APPROVED DRAWINGS HAVE BEEN RED LINED INDICATING A CHANGE TO MEET THE OBC. PLEASE REVIEW ALL PAGES TO ENSURE YOU ARE PROPERLY INFORMED OF CHANGES.

These Plans have been examined for Compliance with the Ontario Building Code requirements. A Building Permit has been Issued, subject to any changes noted, under the condition that the building will be constructed in accordance with the code.

Legacy

client
Tice River Homes
project
Legacy

BASEMENT PLAN ELEV. 'B', 'C', 'D'

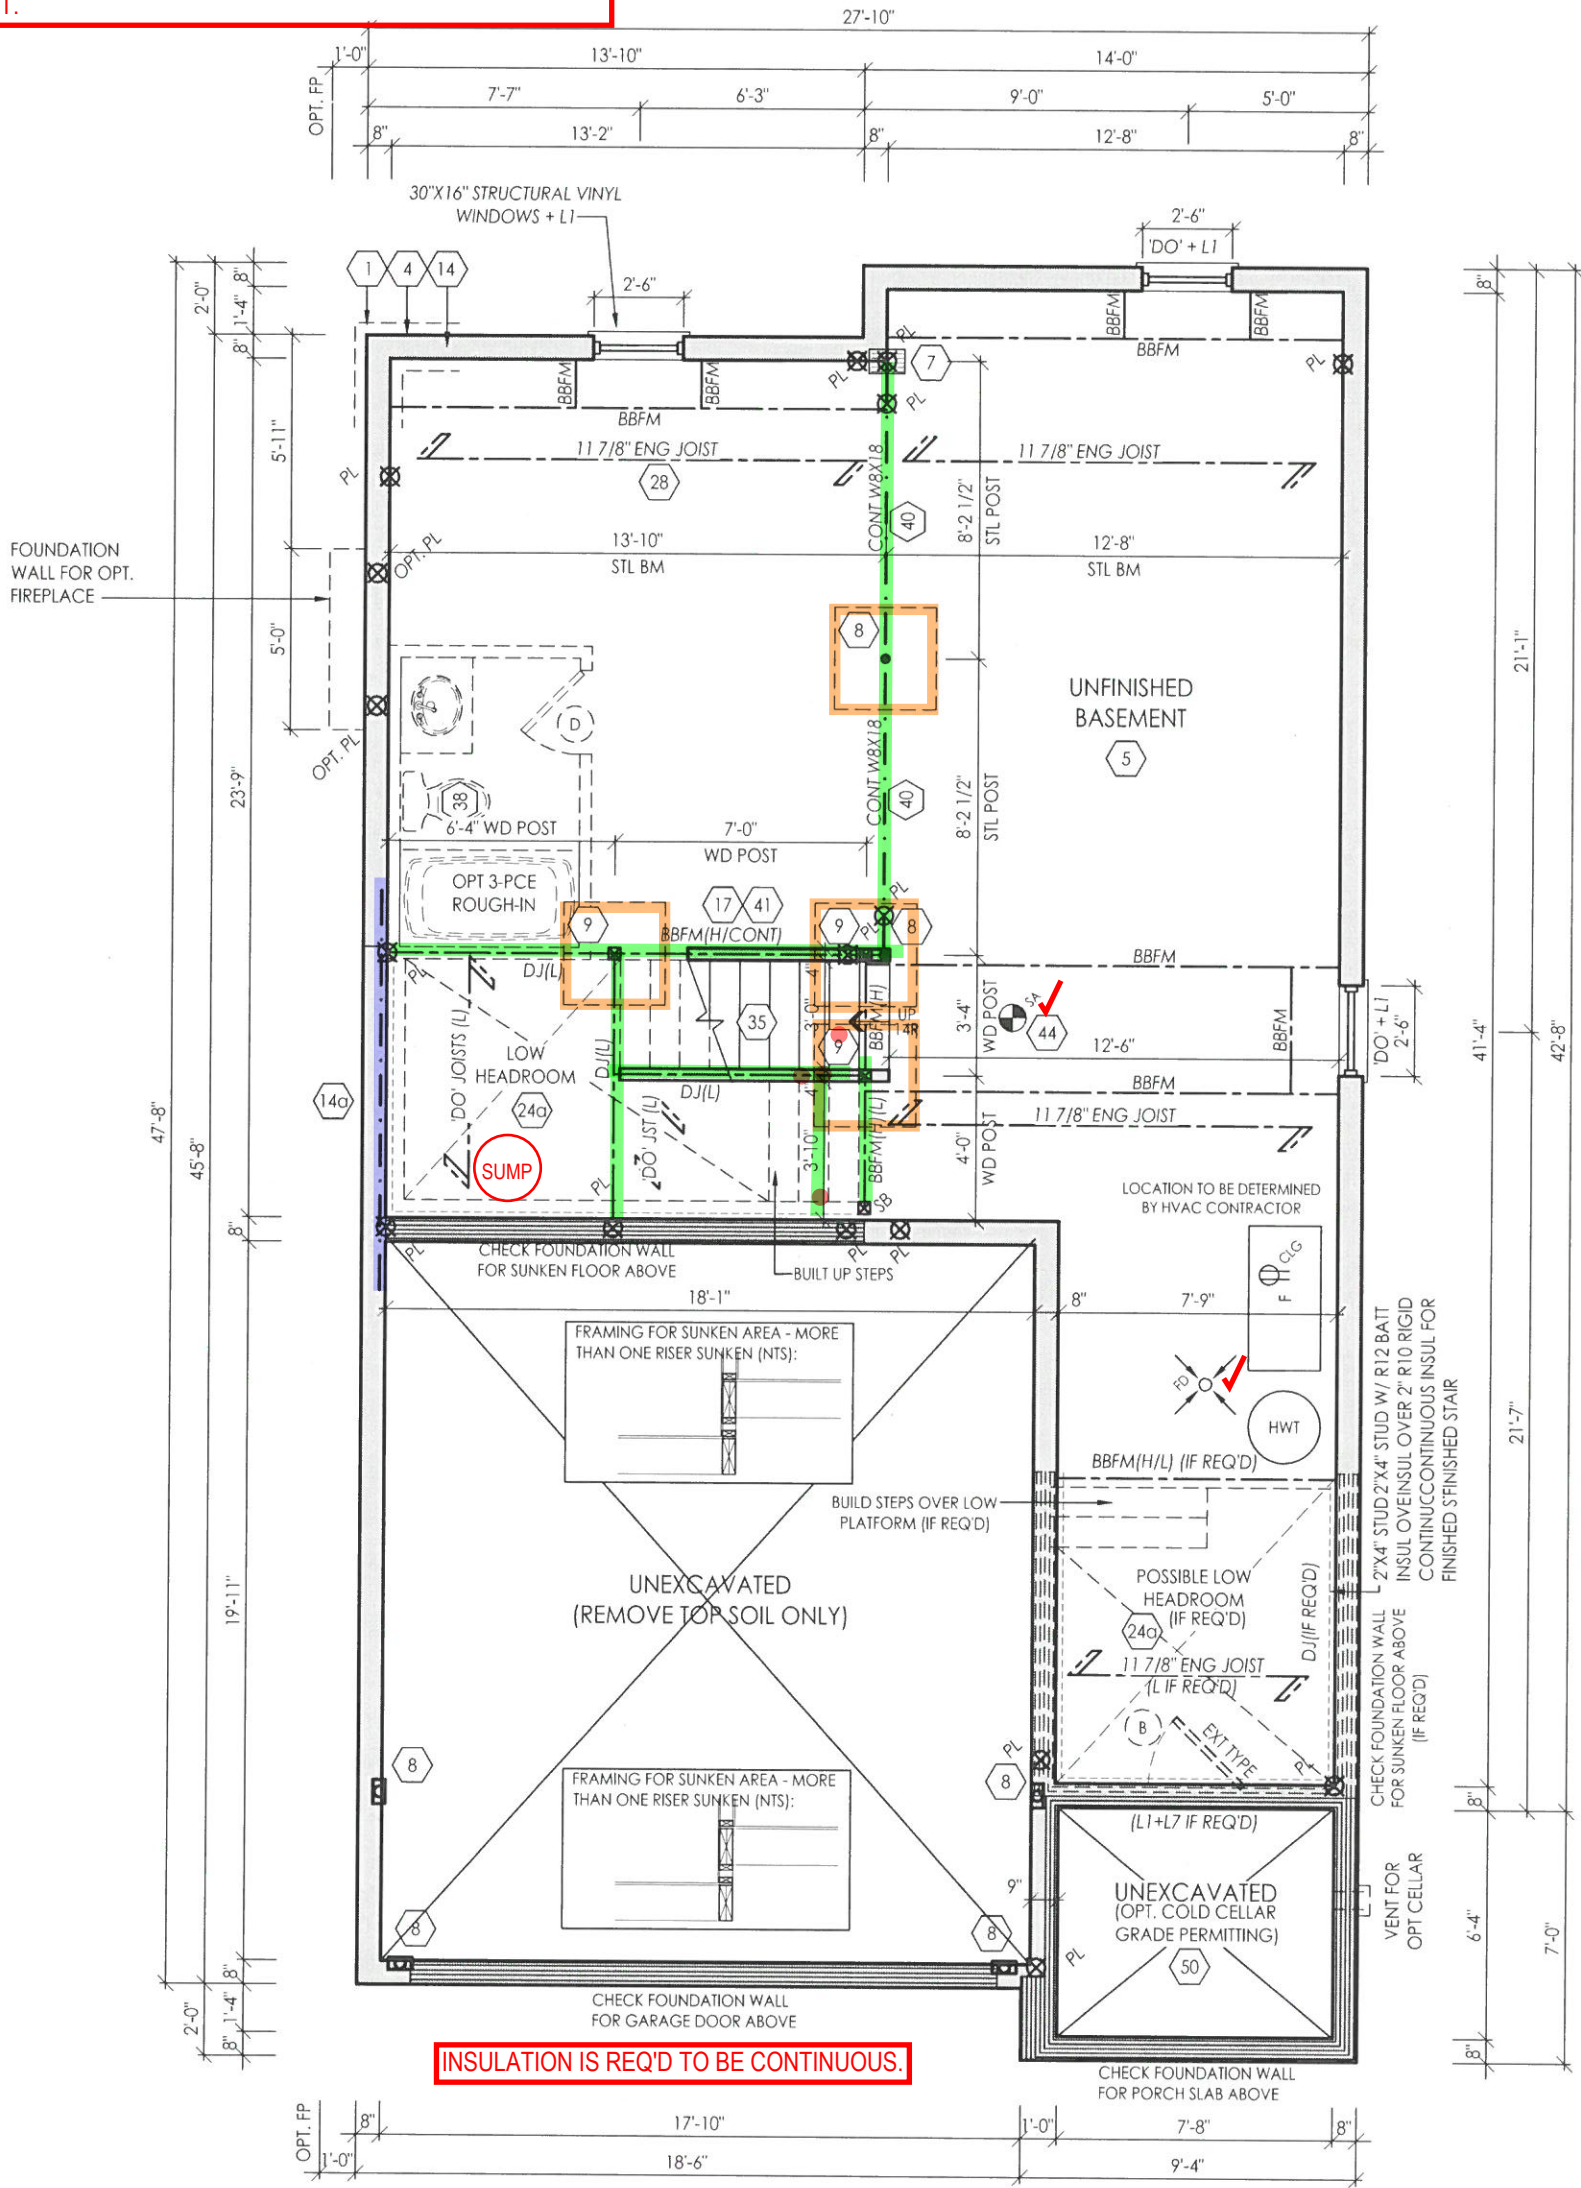
SUMP PUMP/PIT SHALL BE INSTALLED AND CONNECTED ACCORDING TO LOCAL REGULATIONS.

SUMP PUMP LIDS, JOINTS AT INTERSECTIONS & ALL PENETRATIONS OF SLAB MUST BE SEALED TO PREVENT AIR LEAKAGE.

A SEPARATE BUILDING PERMIT WILL BE REQUIRED TO FINISH THE BASEMENT.

INSULATION IS REQ'D TO BE CONTINUOUS.

THE COLD CELLAR DOOR NEEDS TO BE INSULATED AND WEATHER-STRIPPED.

GROUND FLOOR ELEV. 'C'

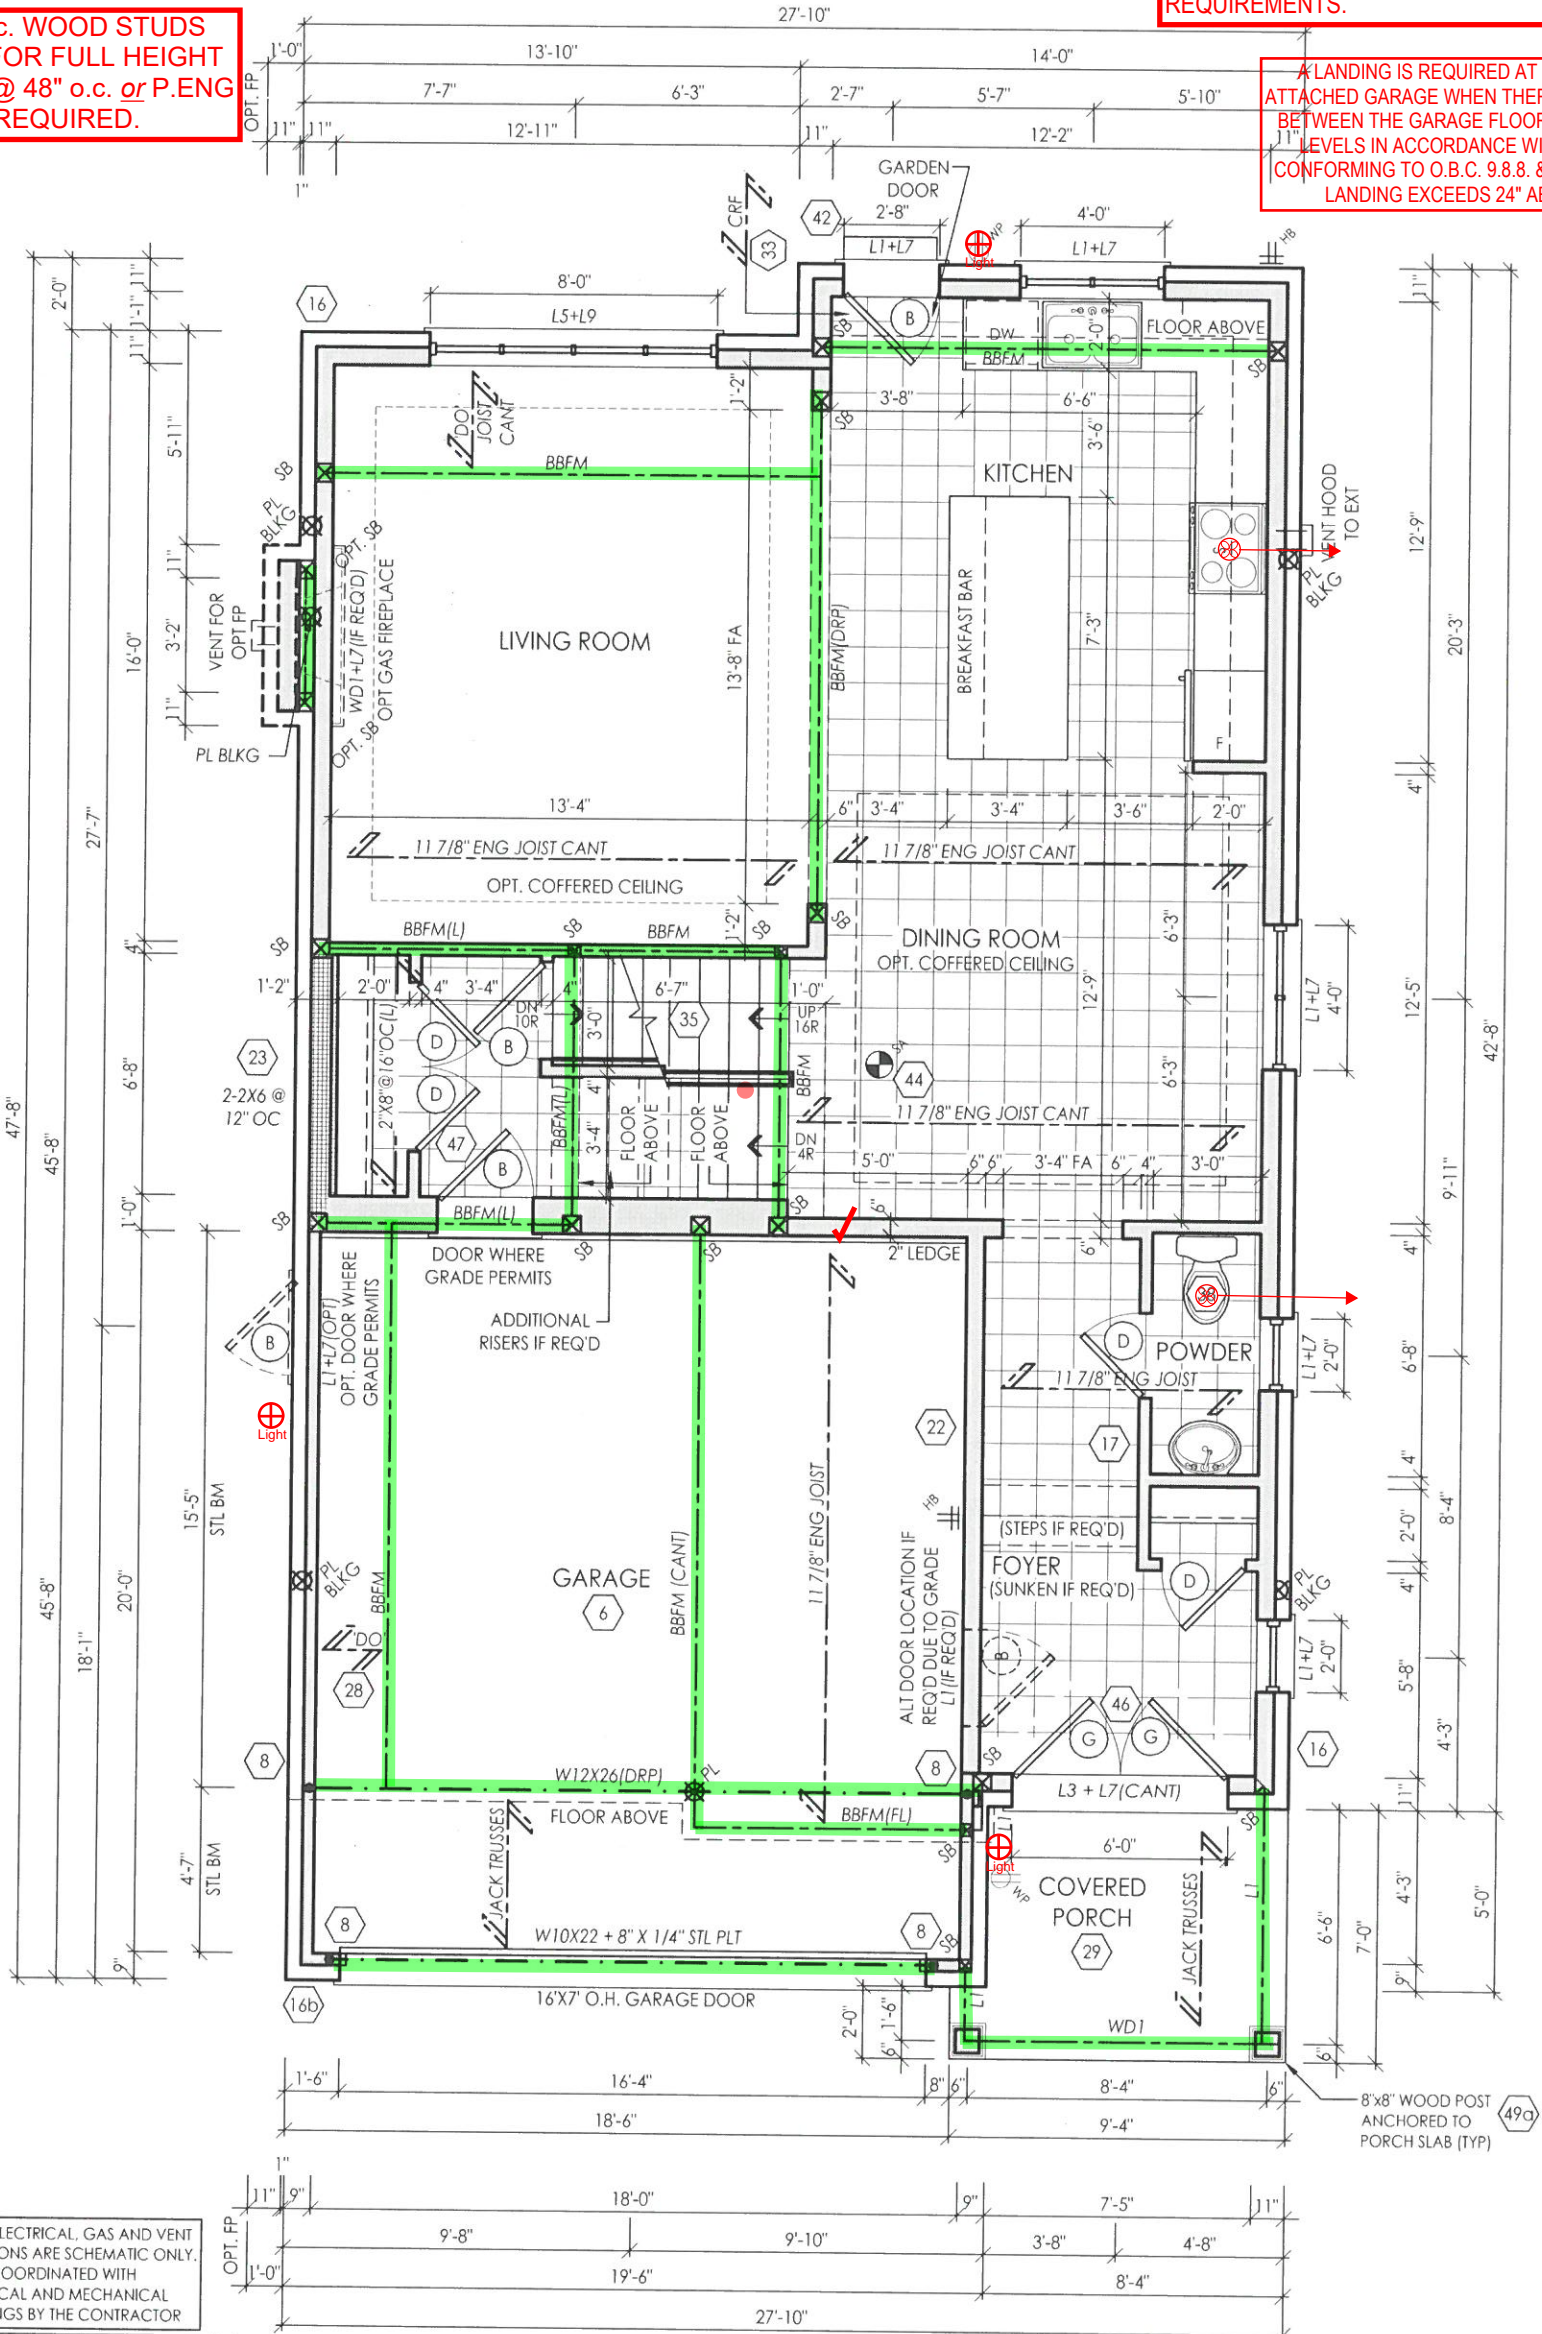
SMOKE ALARMS WITH VISUAL ALARM ARE REQUIRED ON EACH FLOOR AND IN EACH BEDROOM INCLUDING A SMOKE/CO IN THE HALL THAT SERVICES THE BEDROOM.

2"X6" @ 16" o.c. WOOD STUDS CONTINUOUS FOR FULL HEIGHT c/w BLOCKING @ 48" o.c. or P.ENG DESIGN REQUIRED.

A LANDING IS REQUIRED AT THE ENTRANCE FROM AN ATTACHED GARAGE WHEN THERE ARE MORE THAN 3 RISERS BETWEEN THE GARAGE FLOOR AND THE INTERIOR FLOOR LEVELS IN ACCORDANCE WITH 9.8.6.2.(3)(a). GUARDS CONFORMING TO O.B.C. 9.8.8. & SB-7 ARE REQUIRED WHEN LANDING EXCEEDS 24" ABOVE GARAGE FLOOR.

SECOND FLOOR ELEV. 'C'

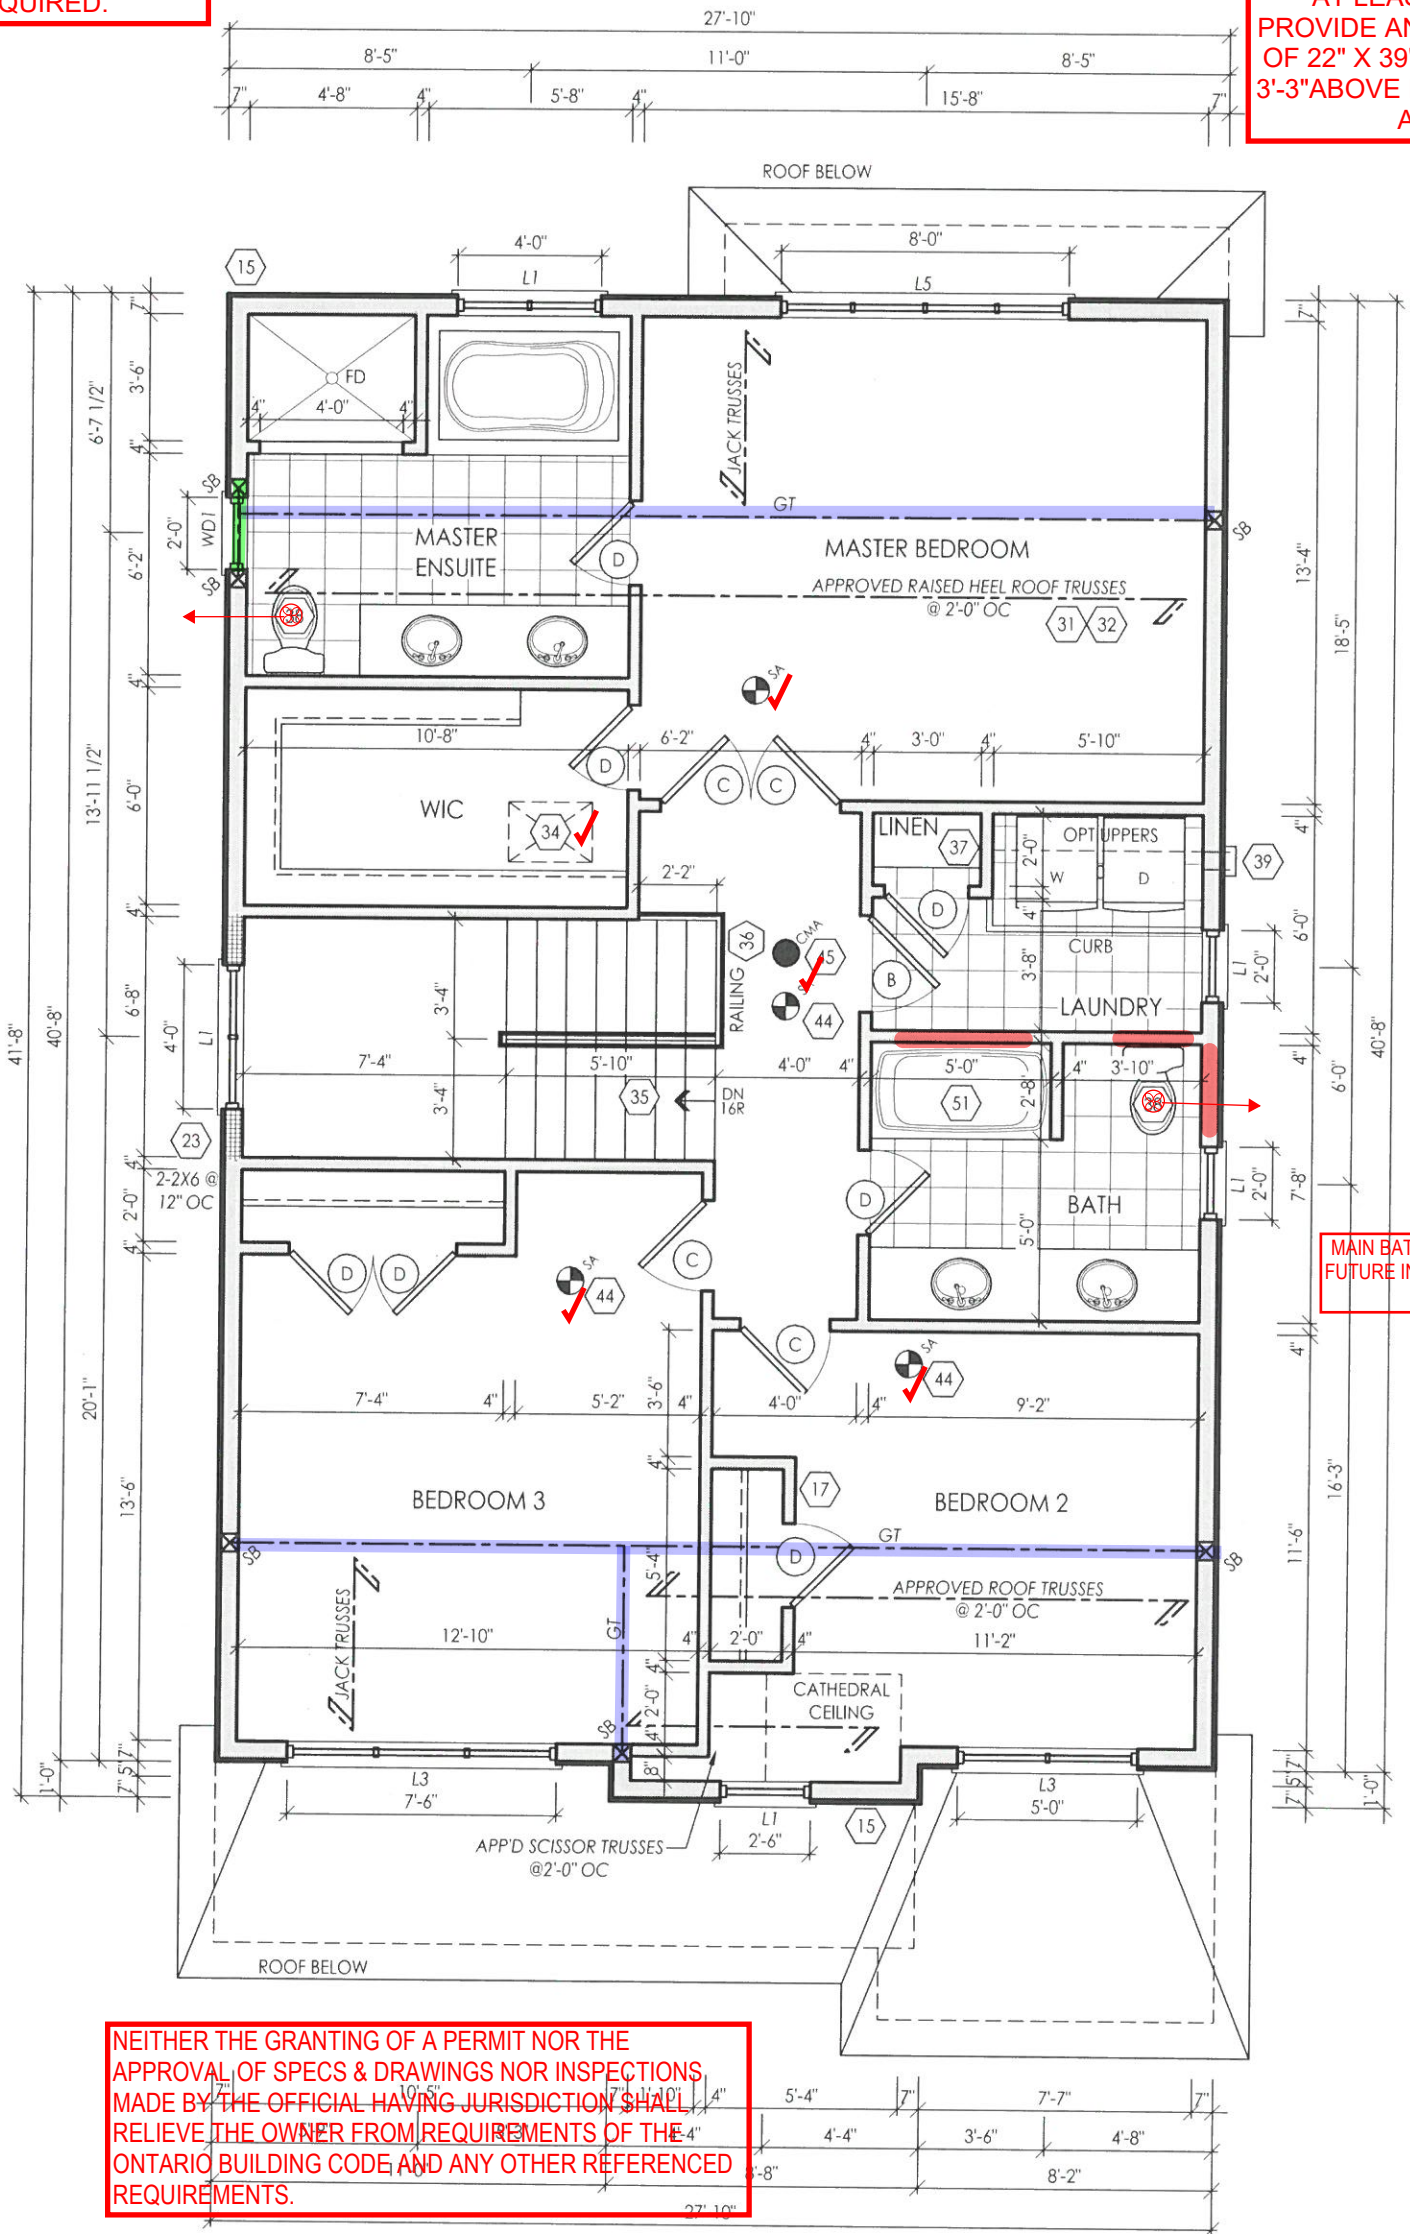
WINDOW SILL TO BE MINIMUM 2'-11" ABOVE STAIR/LANDING, OR BE PROTECTED BY A GUARD, OR BE DESIGNED TO WITHSTAND THE LOADS.

2"X6" @ 16" o.c. WOOD STUDS CONTINUOUS FOR FULL HEIGHT c/w BLOCKING @ 48" o.c. or P.ENG DESIGN REQUIRED.

SMOKE ALARMS WITH VISUAL ALARM ARE REQUIRED ON EACH FLOOR AND IN EACH BEDROOM INCLUDING A SMOKE/CO IN THE HALL THAT SERVICES THE BEDROOM.

AT LEAST 1 WINDOW SHALL PROVIDE AN UNOBSTRUCTED AREA OF 22" X 39" W/ A SILL HEIGHT MAX. 3'-3" ABOVE FINISHED FLOOR & 23'-0" ABOVE GRADE

MAIN BATHROOM TO HAVE STUD BLOCKING FOR FUTURE INSTALLATION OF GRAB BARS ADJACENT TO SHOWER/TUB AND TOILET.
